From: Mess, Camie
Sent: Friday, January 26, 2018 4:02 PM
To: julia@dinsmorehouse.com
Subject: BAR Action- January 17, 2018 - 1211 West Main Street

Certificate of Appropriateness Application
BAR 16-06-04
1211 West Main Street (Dinsmore House Inn)
Tax Parcel 100059000
1817 House LLC, Owner/Ryan Hubbard, Applicant
Amendments to the approved COA

**CITY OF CHARLOTTESVILLE
BOARD OF ARCHITECTURAL REVIEW
STAFF REPORT
January 17, 2018**

Amendments to the approved COA

CONCEPT PLAN

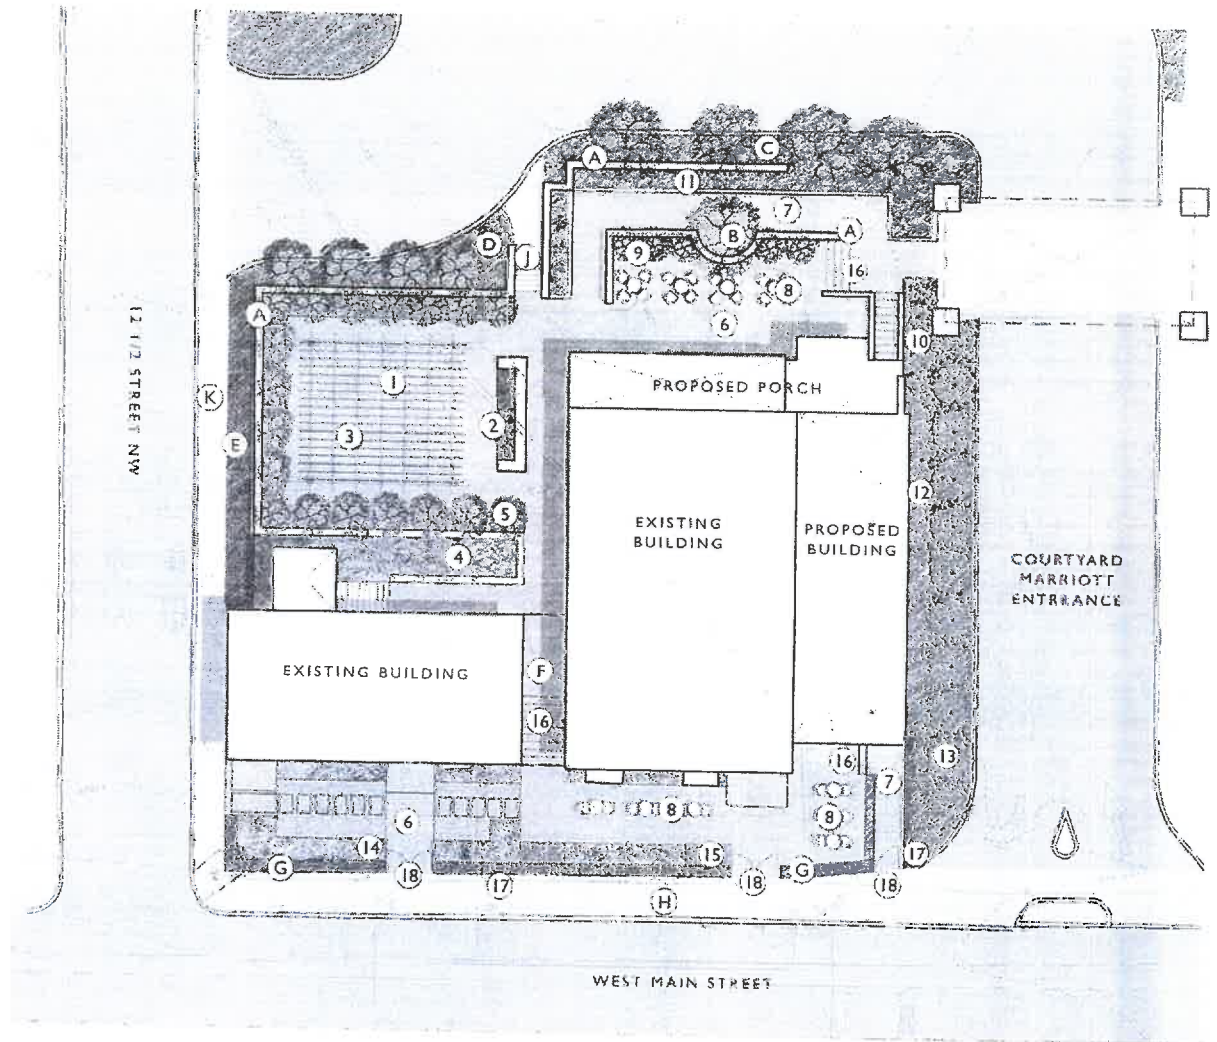
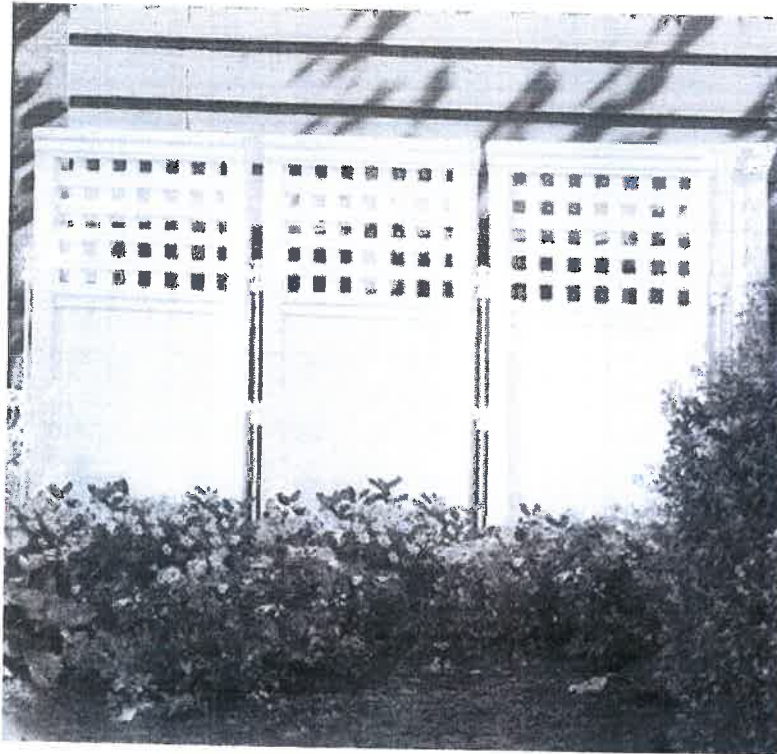
- Landscape Variance Request [Total Canopy Calculation: 1943 SF As-is - Required 902SF]
 - o Spaced Cryptomyeria and Otto Luyken Laurel along East Façade to allow natural light to come through the four fire windows – balanced between copper gutter/scuppers. We are going to replace the (3) Cryptomyeria with (5) Armstrong Maples equidistant along the East Façade and bond this landscape amendment with the City of Charlottesville.

- o Existing River Birch trees in the courtyard behind the building took on enormous stress during site work (primarily root damage) which left aged trees susceptible to disease. The two River Birch trees had to be removed and we are considering pergola or trellis system as suggested by Water Street Studios.

- o Added Magnolia Trees to break up guest room entrance to courtyard space that was not on the approved site plan.
 - o Front entrance to townhouse space hardscaped to ensure ease for guests to roll luggage.

- o **Hot pots to be designed/planted seasonally in indicated spaces on drawings.**

Schwarz moved: Having considered the standards set forth within the City Code, including City Design Guidelines for New Construction and Additions, I move to find that Certificate of Appropriateness amendment for the new construction and addition satisfies the BAR's criteria and is compatible with this property and other properties in the West Main Street ADC district, and that the BAR approves the application for not white washing the brick and for the mechanical screen as submitted. The BAR would like the applicant to come back with an as built landscape plan, and a proposed landscape plan that actually matches what was discussed in the meeting, with an attempt to replace the canopy that was lost in the back. Gastinger seconded. Approved (6-0.)

LANDSCAPE PLAN
sheet title

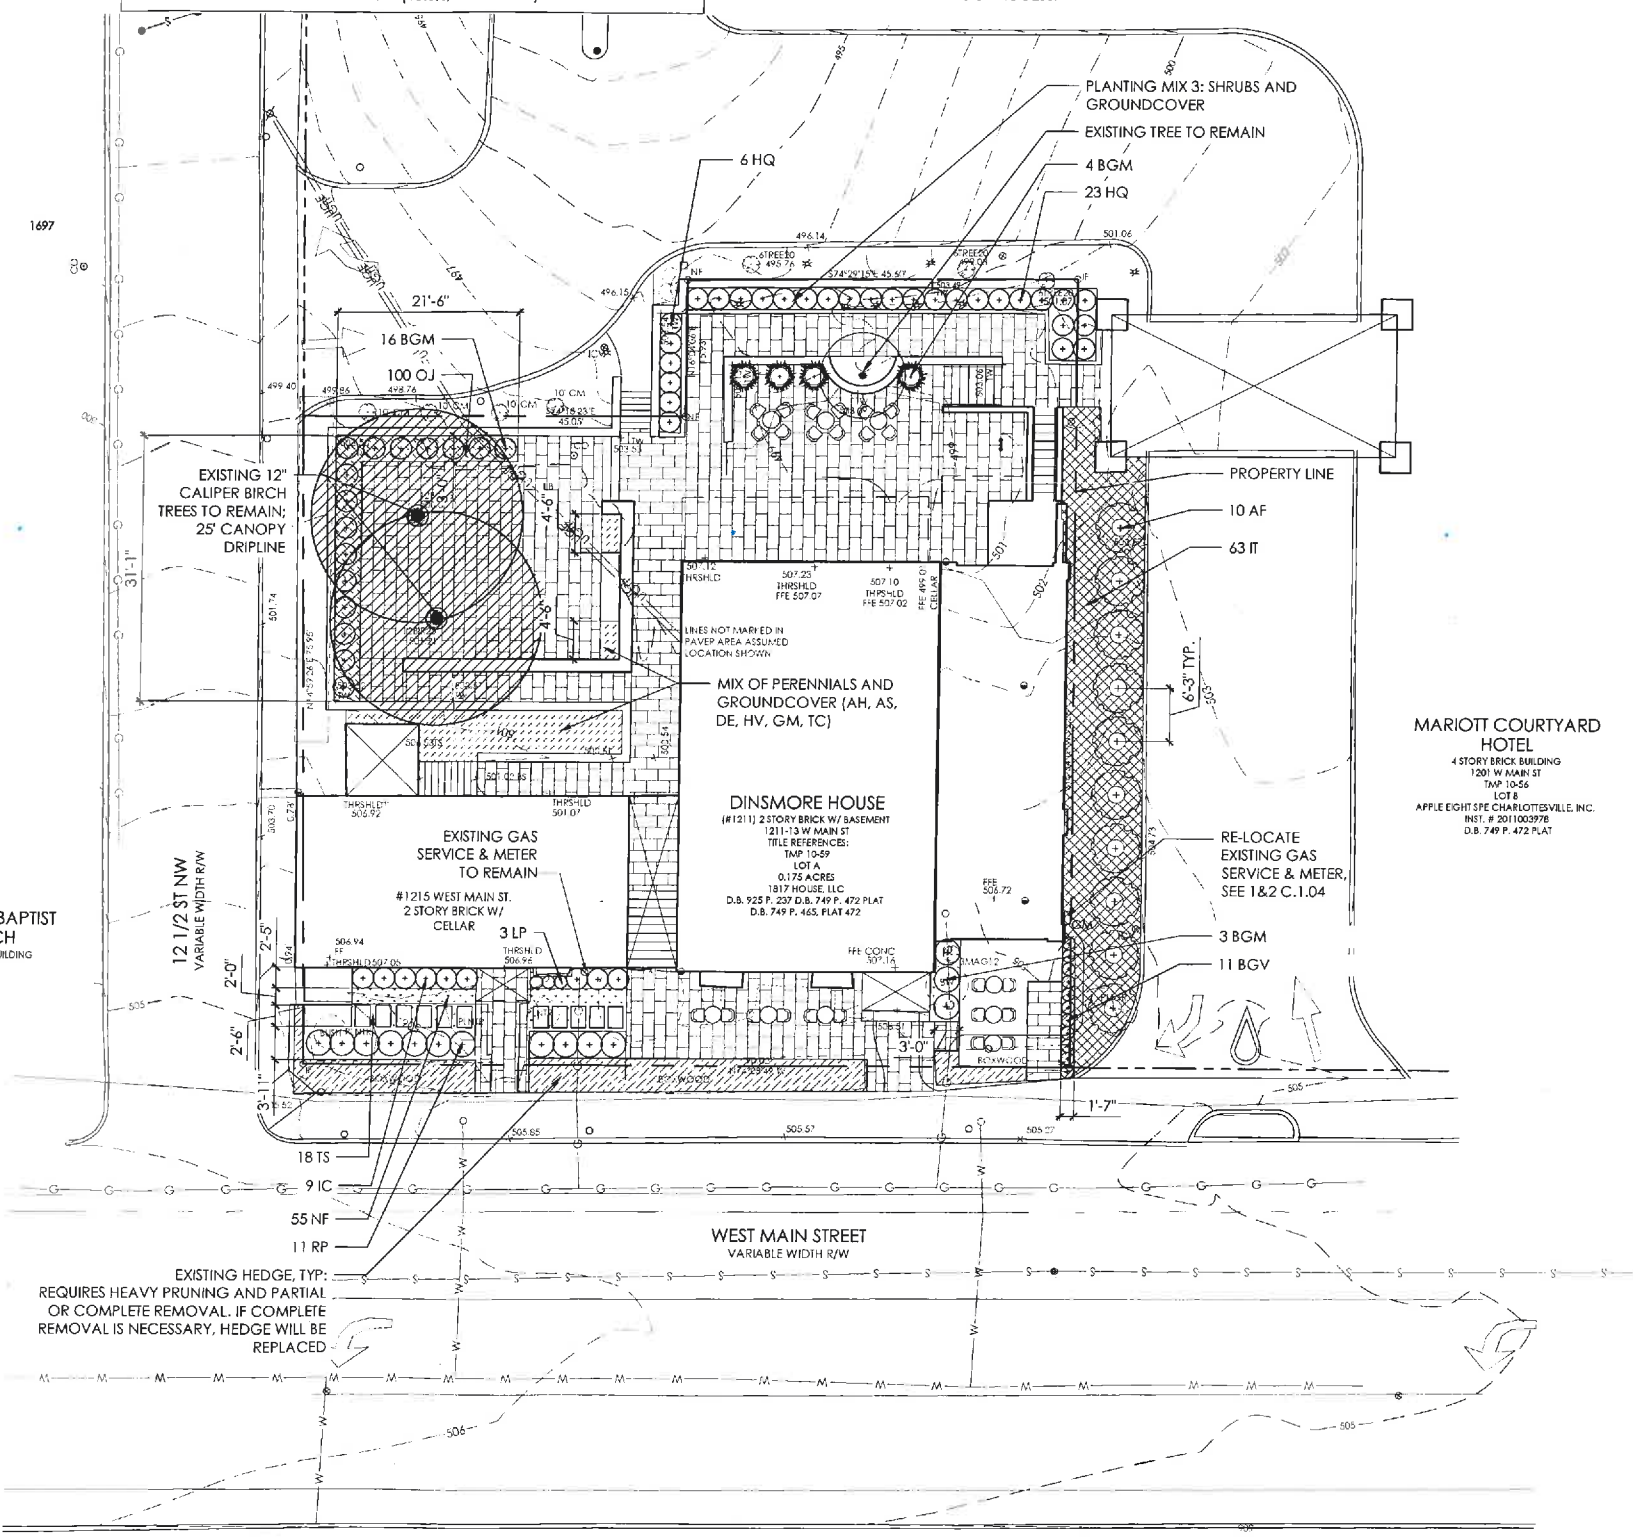
In the spirit of the City Code Sec. 34-866 (below)... regarding the two (2) 12" River Birch trees that were removed, the Planner would recommend two comparable trees be replanted there. The changes to the site will likely require a site plan amendment for planning records, where landscape plan would be reviewed by Urban Forester.

1. They failed to plant 10 Armstrong Red Maple on east side. If they want to reduce that total number the BAR may OK that but they likely won't approve the shrubs and 3 Leland cypress they installed in lieu of Maples. Tree canopy issue also.

2. They removed two -12" caliper birch trees in the rear patio (phoso in next email) that are shown to be saved on site plan. They added some magnolias in a different location (but not on the plan) that look fine. There is probably a tree canopy issue, and the BAR will possibly want two shade trees planted in the patio.
3. The front patio design and landscape have been simplified but I think the BAR will be OK with it.
4. They failed to screen the rooftop mechanical. I asked Julia to come up with a design.
5. The brick addition was supposed to have been whitewashed. They will ask the BAR to change that requirement (Jan BAR).
6. The building design has other changes that the BAR must sign off on, but don't affect the site plan. Not sure how to deal with building changes on the CO unless we require them to go to BAR in January with all requested changes.
